**REPORT  
INDEPENDENT HYDROLOGIST REVIEW  
ALTAROCK ENERGY  
EGS DEMONSTRATION PROJECT  
NEWBERRY, OREGON**

**February 24, 2011**

**Subject: Independent Hydrologist Review Report  
AltaRock Energy  
EGS Demonstration Project  
Newberry, Oregon**

PROJECT AREA MAP
INDEPENDENT HYDROLOGIST REVIEW EGS DEMONSTRATION PROJECT NEWBERRY, OREGON

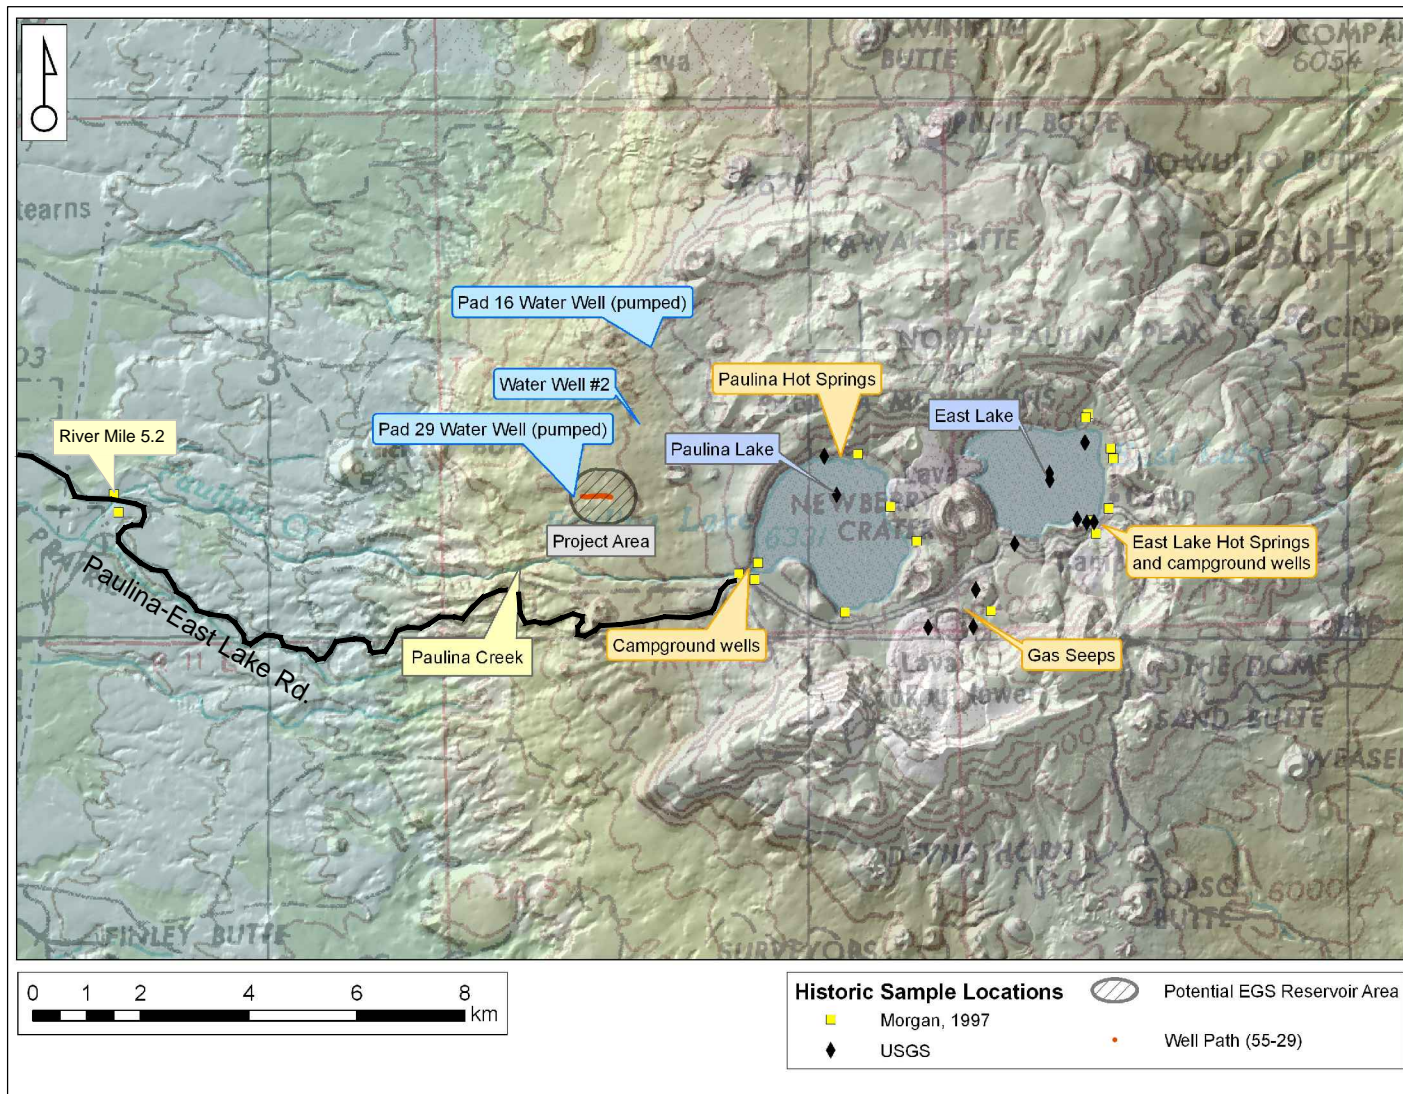
Paulina Creek, at the crossing of County Highway 21 (also known as Paulina-East Lake Road and U.S. Forest Service Road 21) at RM 5.2, has been monitored by the US Geological Survey (Morgan and others, 1997) (Figure 1). The hydrologic flow patterns into Paulina Lake and its connection to the project site aquifer have been discussed in several of the responses provided above. We do not believe there is a need for monitoring of water flow/quality downgradient of the site at surface water bodies.

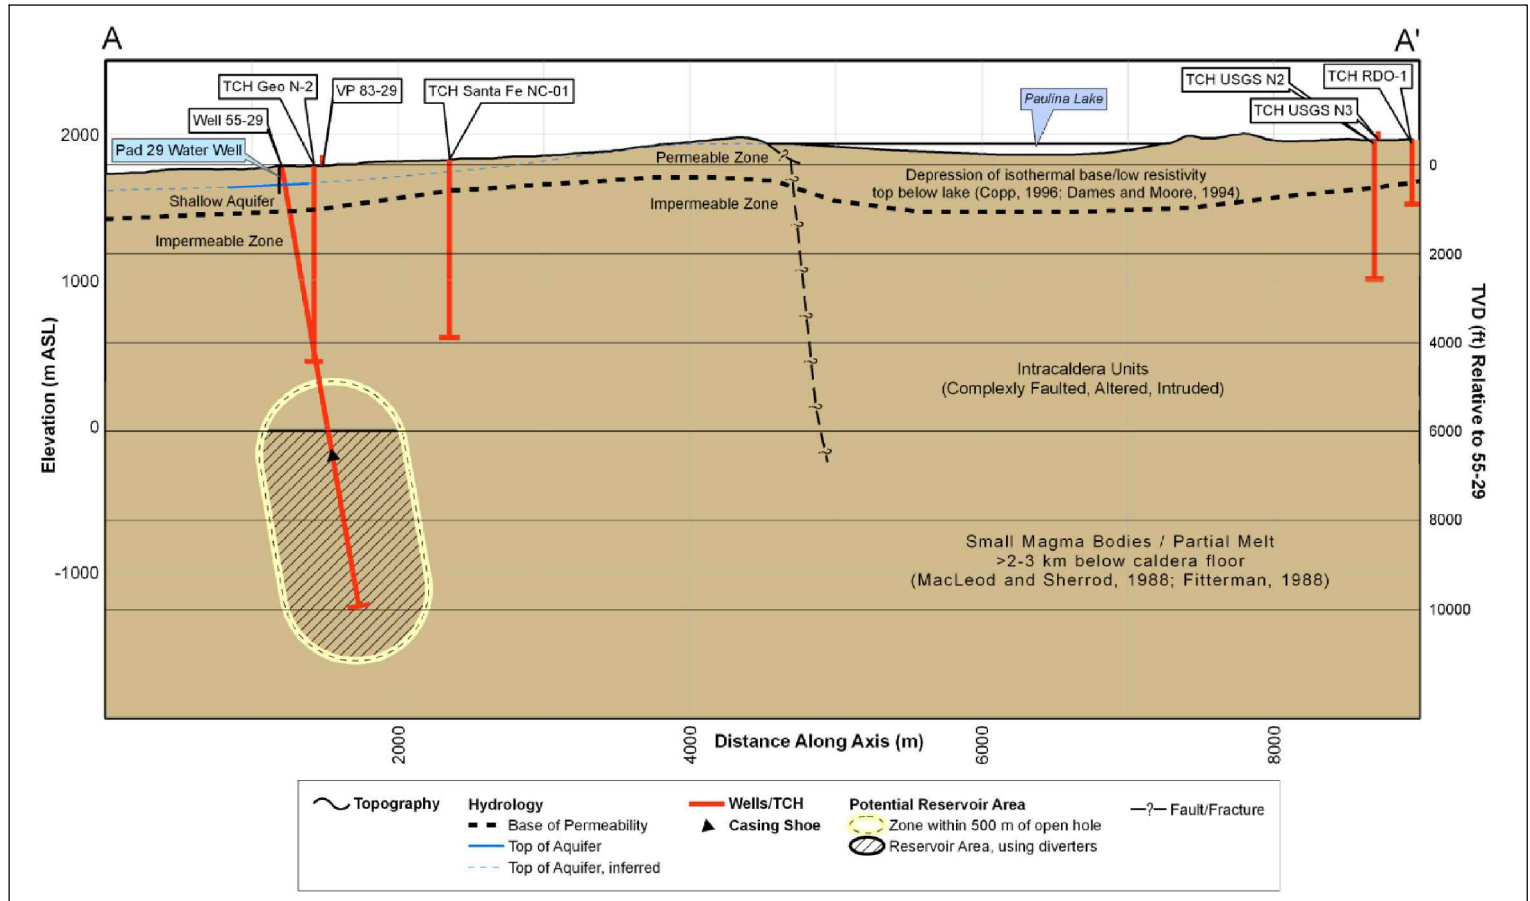
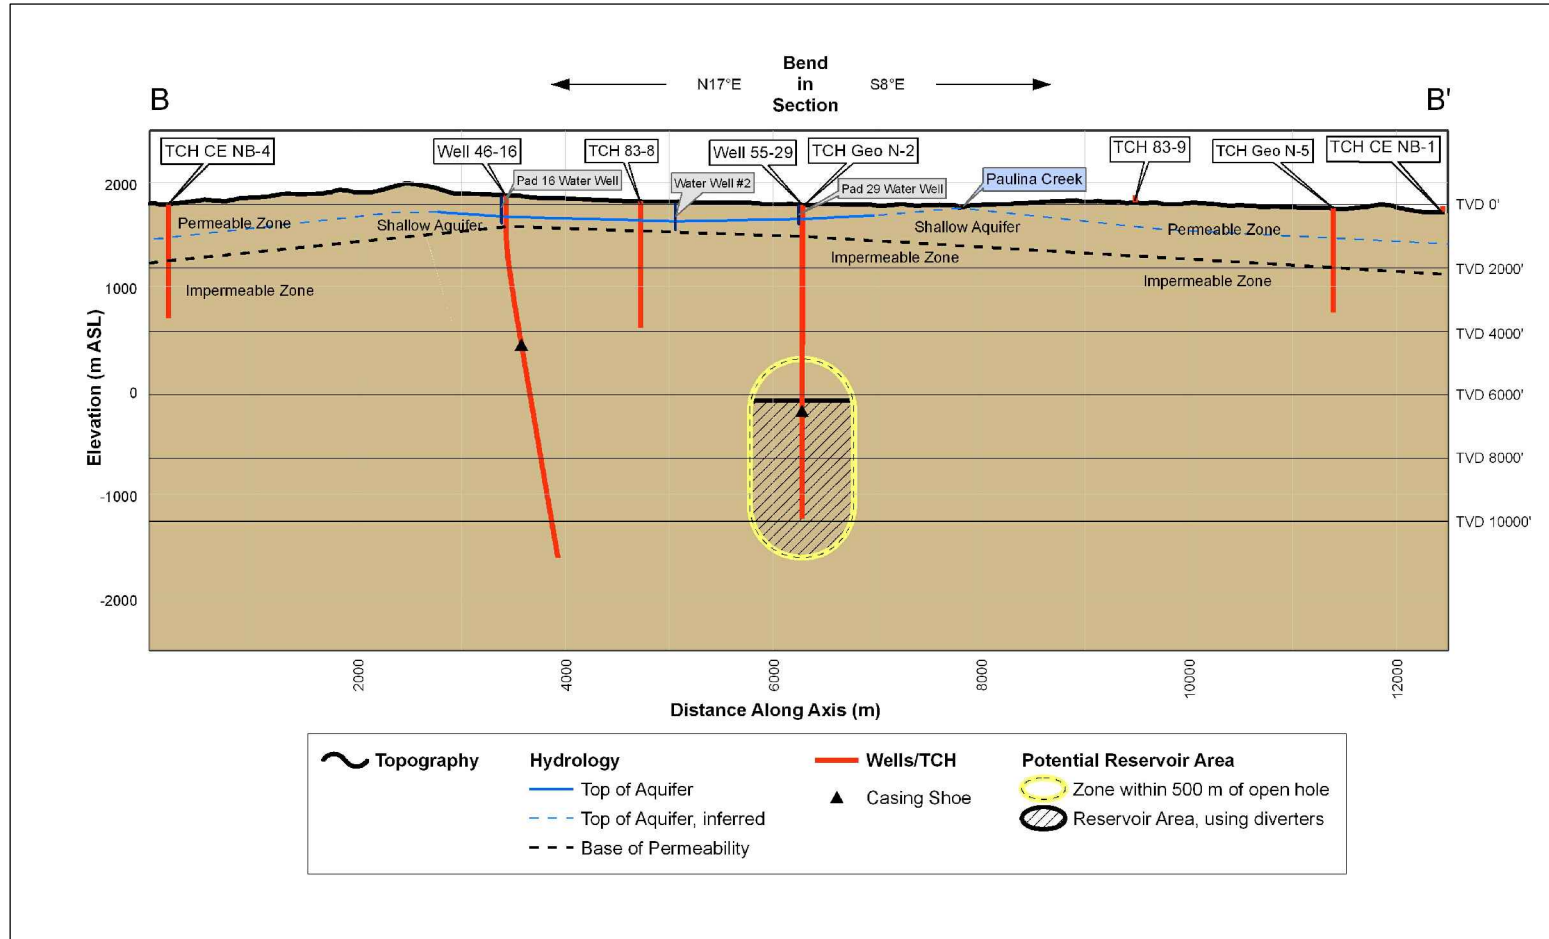
It is our opinion that the risk of development of a hydraulic connection between the proposed EGS reservoir and the shallow (project site) aquifer is extremely low. The hydrologic overview document, Memorandum, Newberry Water Monitoring (Callahan,

2010) provides a summary of the hydrogeologic environment at the proposed test site (Figures 2, 3, and 4). This document along with several others we reviewed (see References section) show the base of the regional aquifer system is approximately 5,000 feet above the top of the proposed EGS reservoir zone. The estimated EGS reservoir created through hydraulic stimulation at the Pad 29 site will be a network of fractures extending approximately 1,500 feet radially. Even if these fractures extended upward from the top of the EGS reservoir zone, it would still be several thousand feet below the bottom of the project site aquifer. Given the very low permeability of the receptor rock throughout the length of the vertical borehole below the project site aquifer, it is unlikely that fluids would be able to migrate vertically during the testing period.
